**Roseau West Interceptor
and
Wetland Restoration Project**
(RRWD Project Number 2003-1)

April 30, 2004

Re: Advisory Review of Revised West Interceptor Preliminary Engineering Report

DIRECTOR'S ADVISORY REPORT; REVISED WEST INTERCEPTOR PRELIMINARY ENGINEERING REPORT

Figure 2. Route of Proposed Interceptor Channel

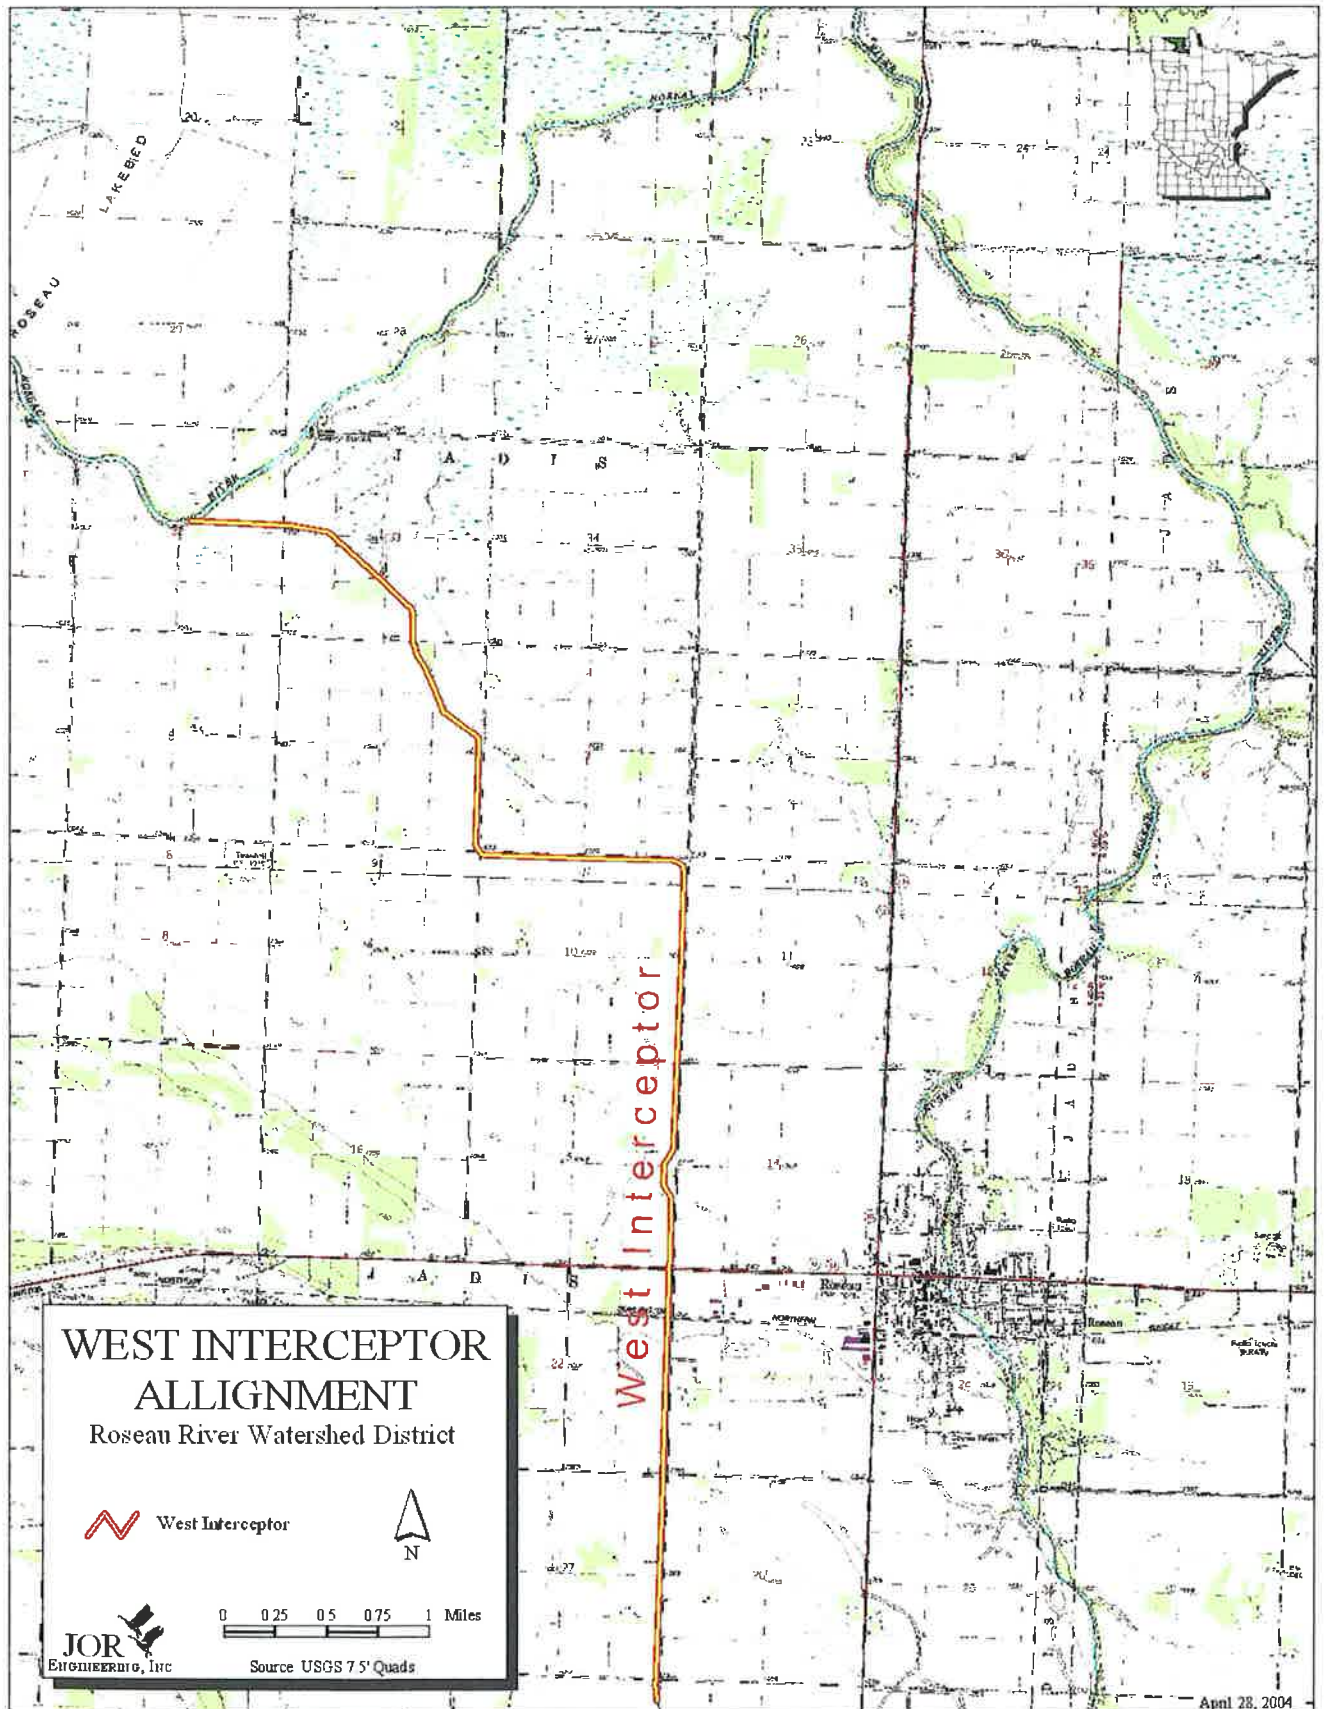
Figure 2. Route of Proposed Interceptor Channel, and Figure 14. Replacement of Farmland Drainage: The proposed channel alignment crosses an existing drainage ditch twice in Section 4, T162N, R40W. It's not clear how the drainage in the existing ditch will be handled. Might it be best to realign the interceptor channel somewhat to avoid crossing the existing drainage ditch?

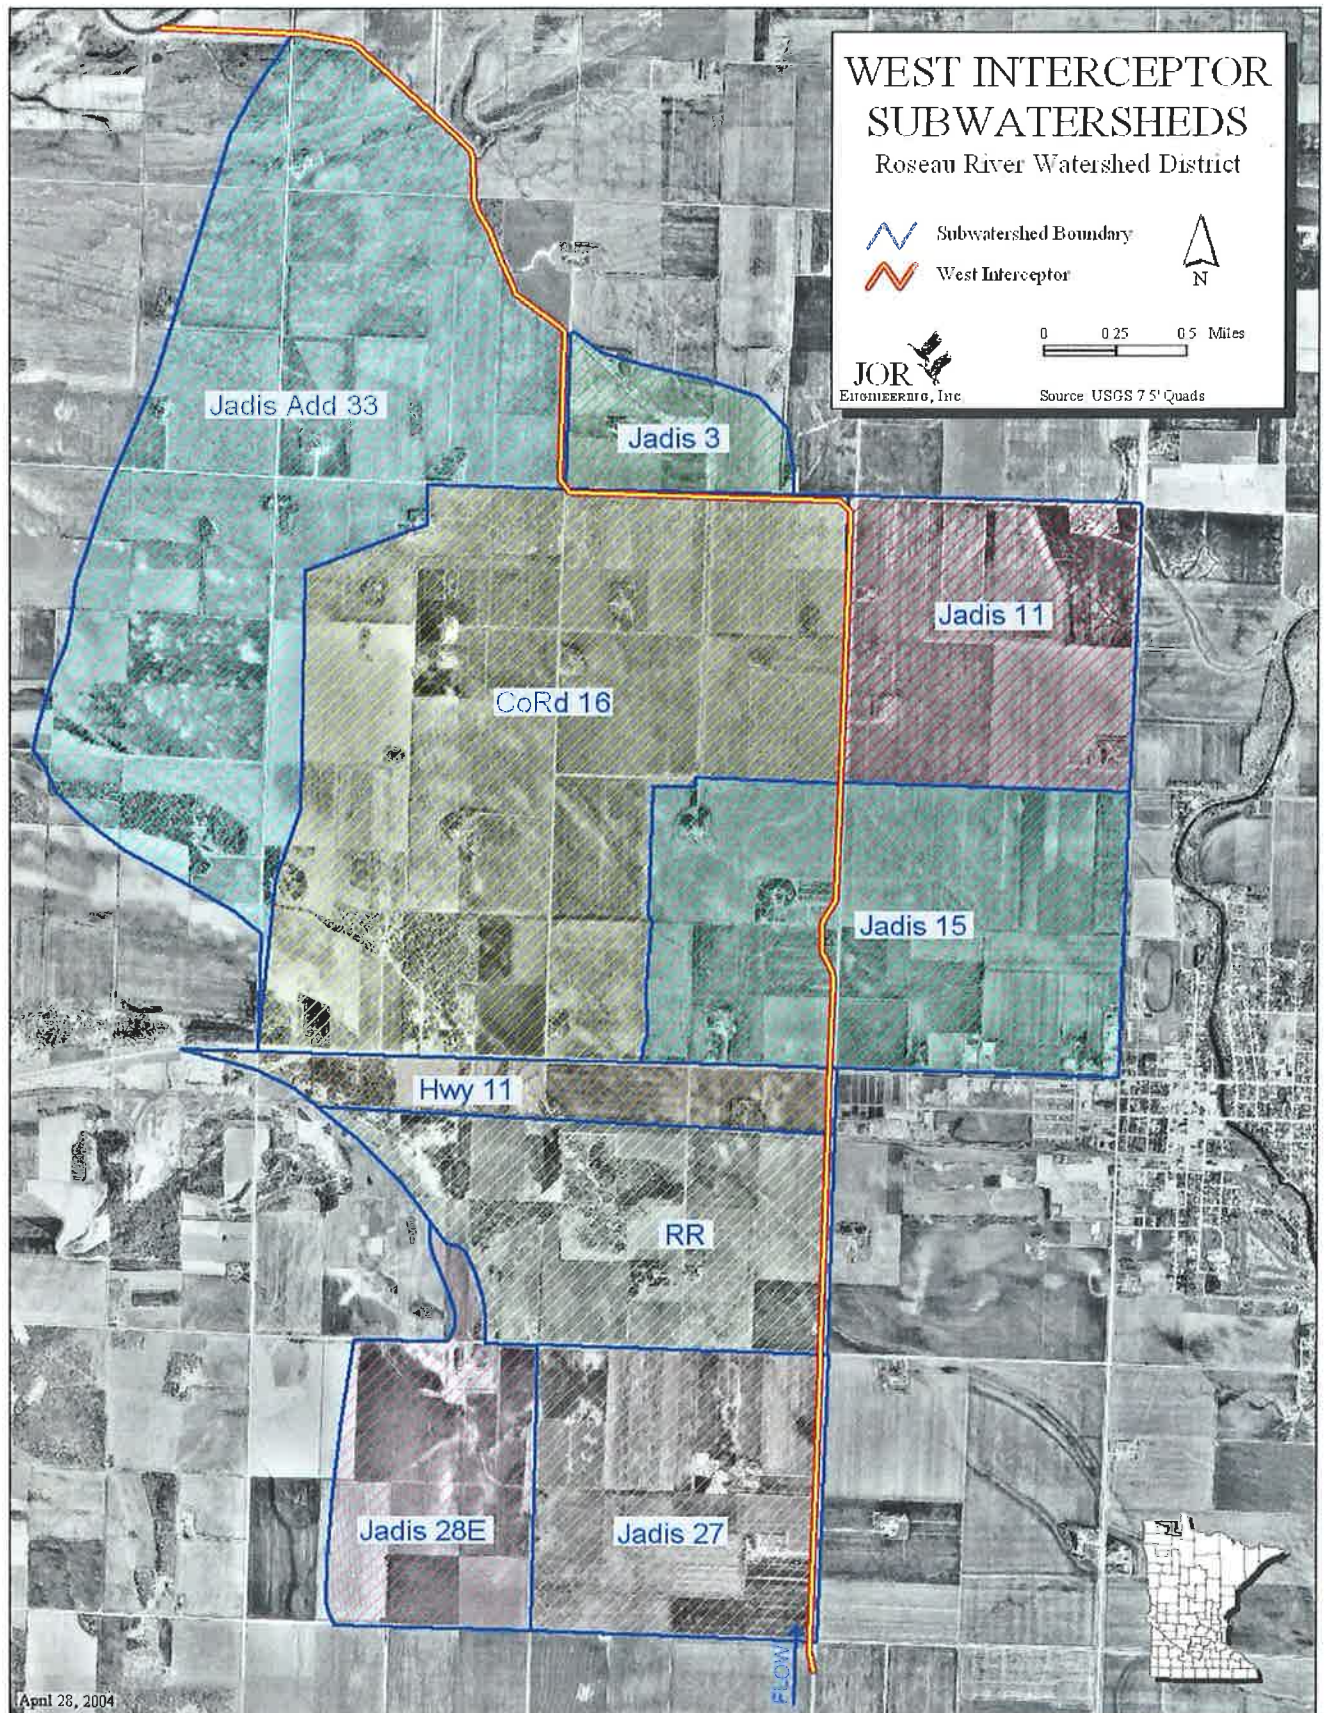
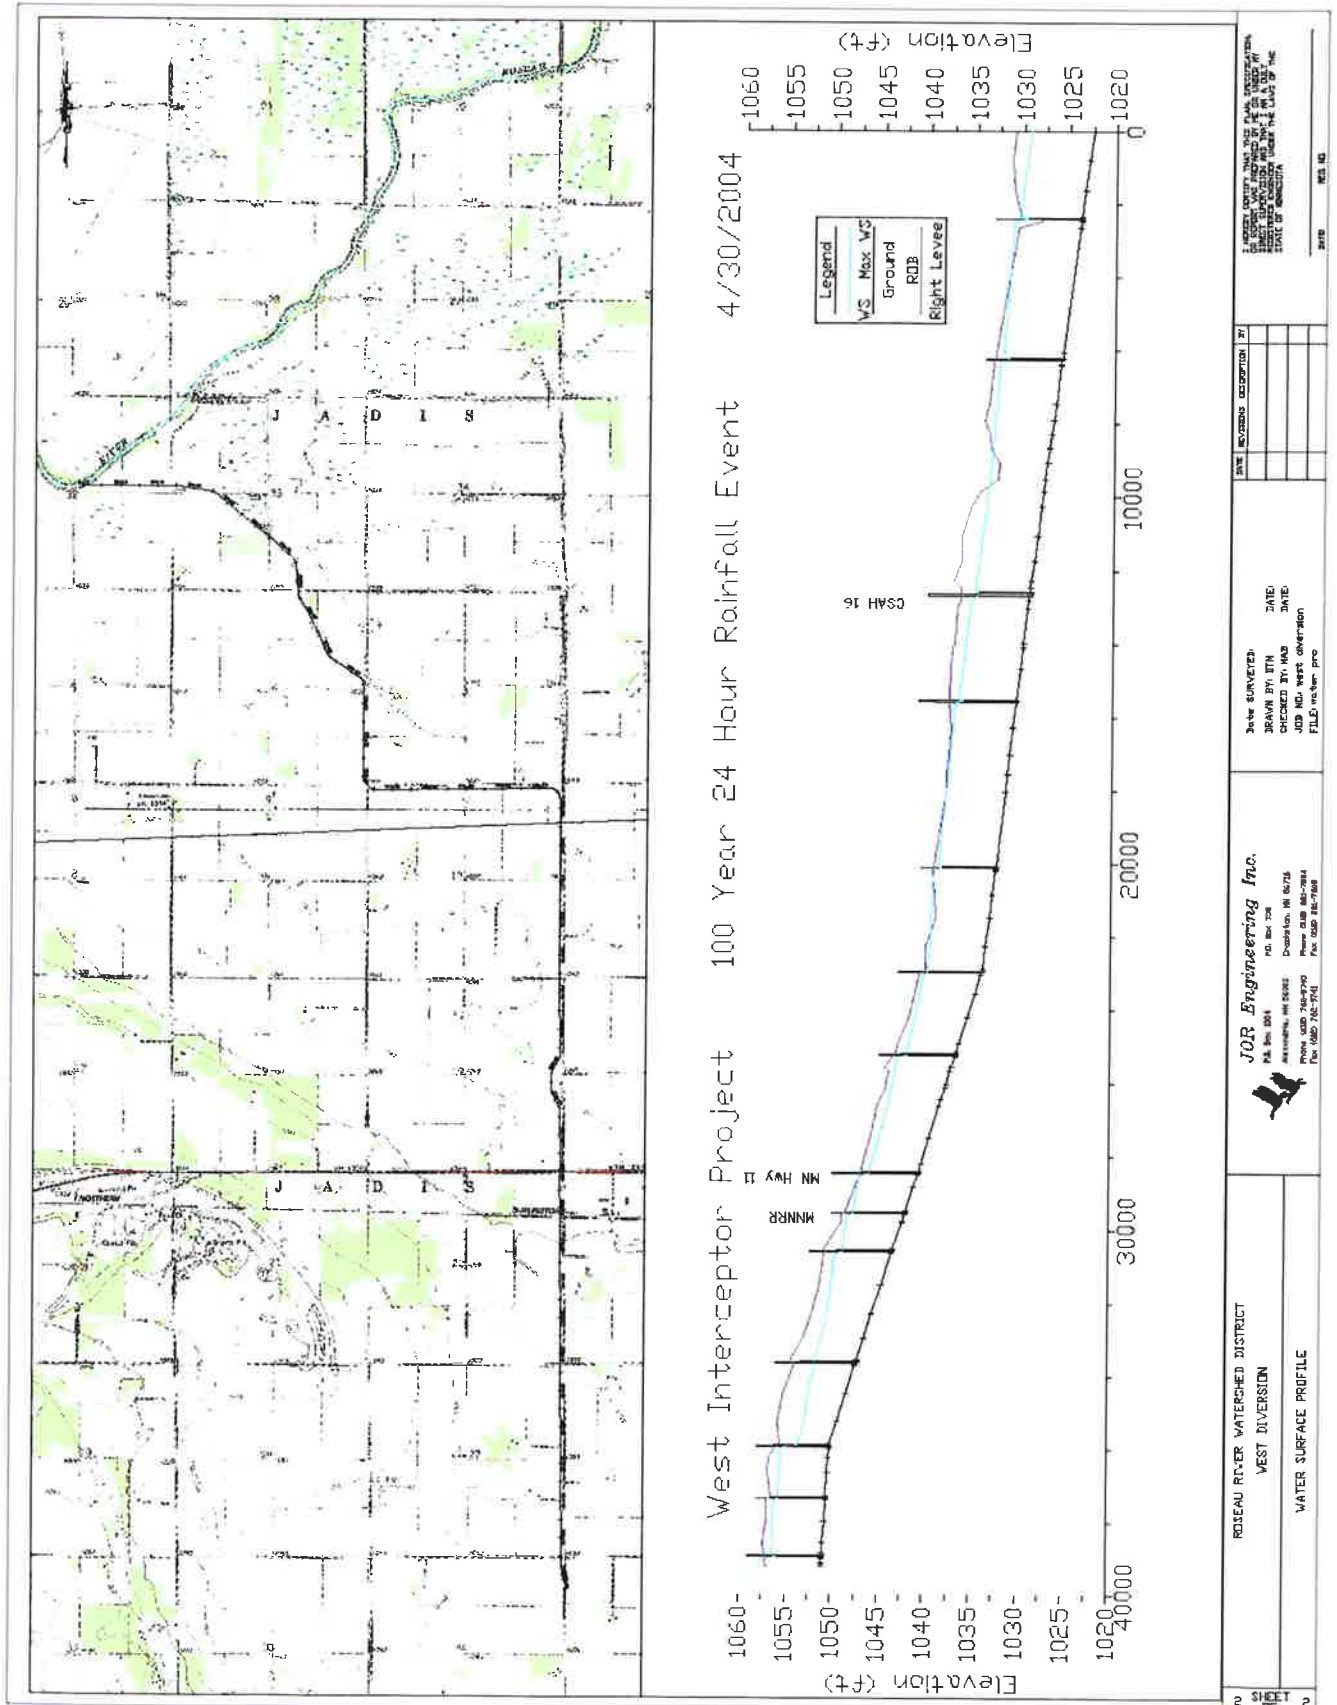
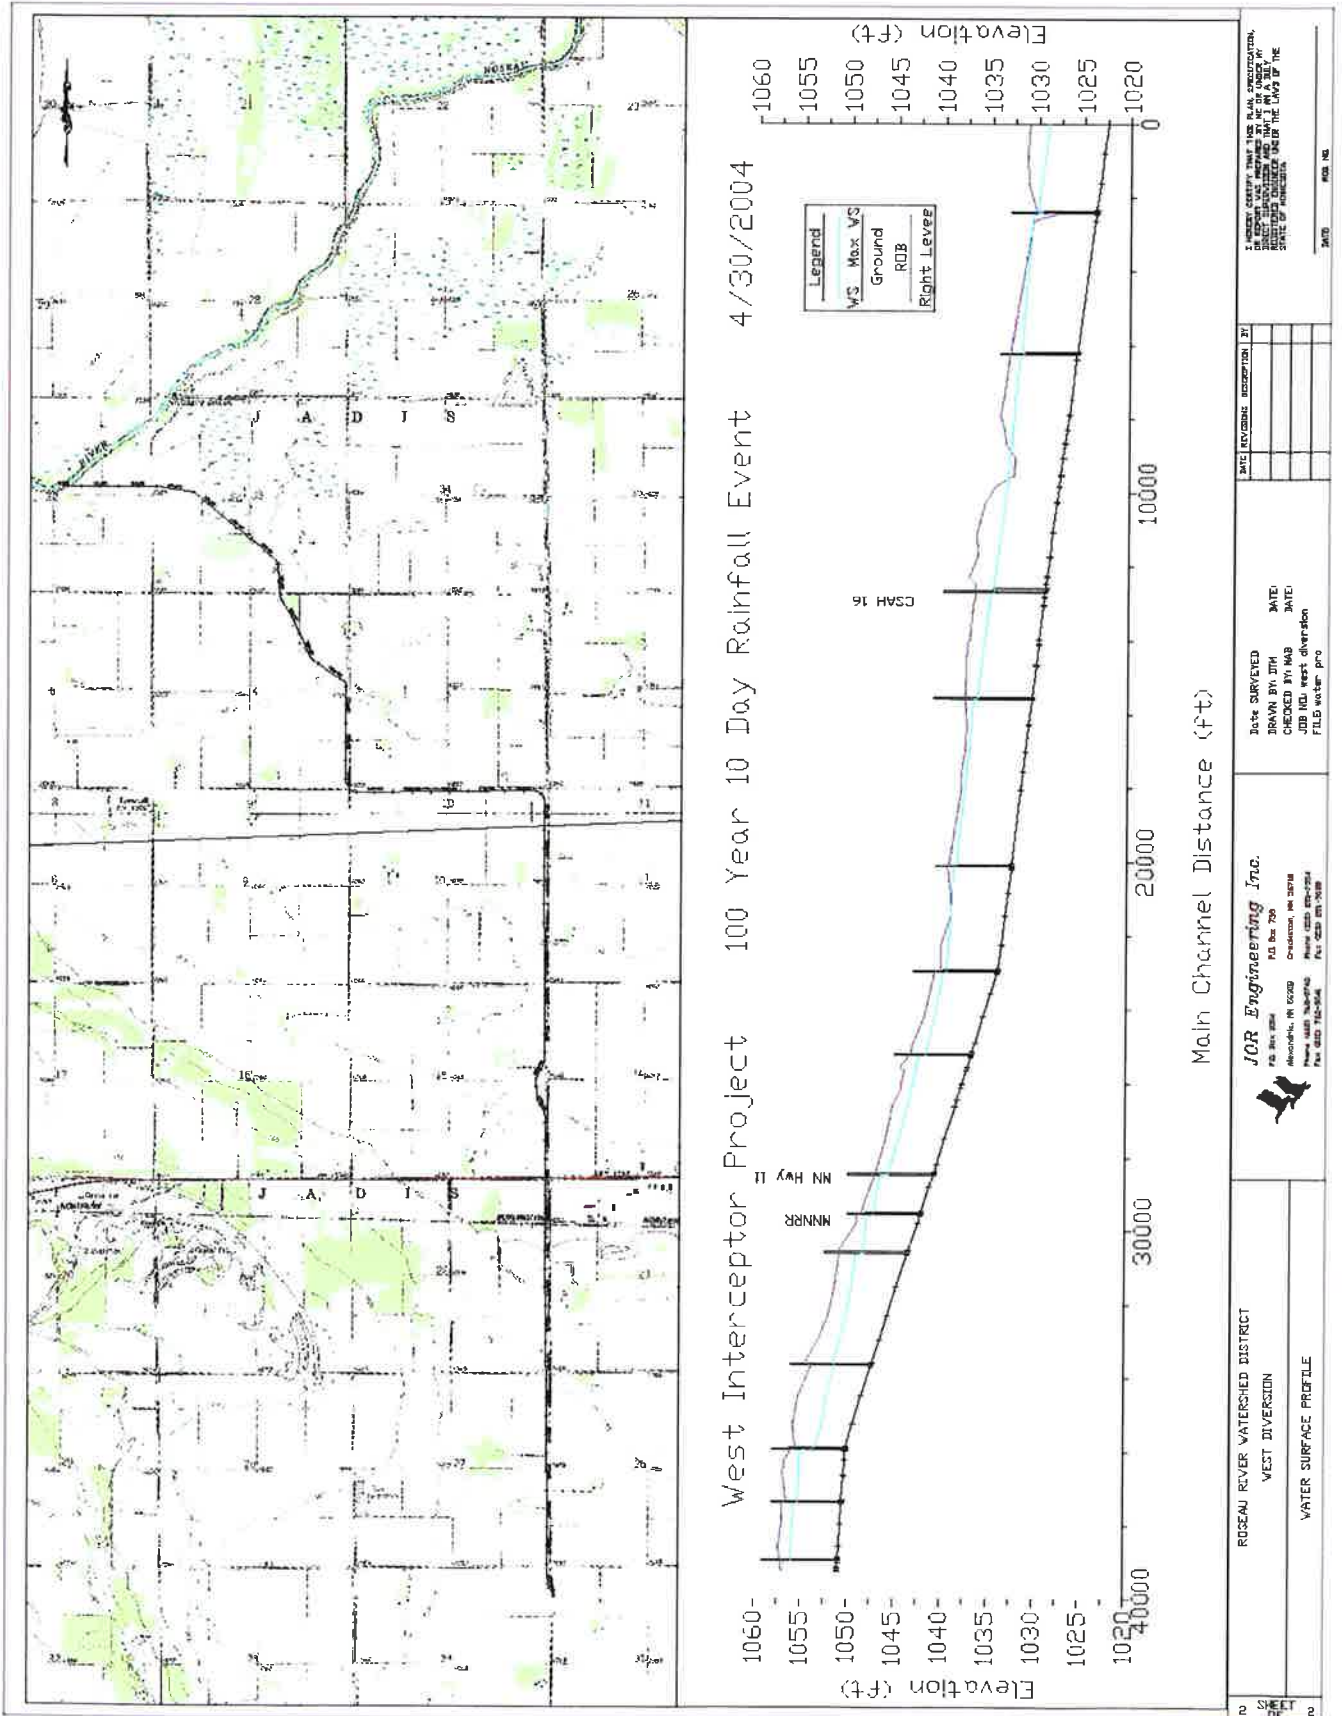
Figures 5, 6 and 7: The legends on these figures are difficult to interpret and do not include a definition of the channel bottom profile. As mentioned in the previous BWSR advisory report for this project, the very small scale of these drawings make them difficult to read.
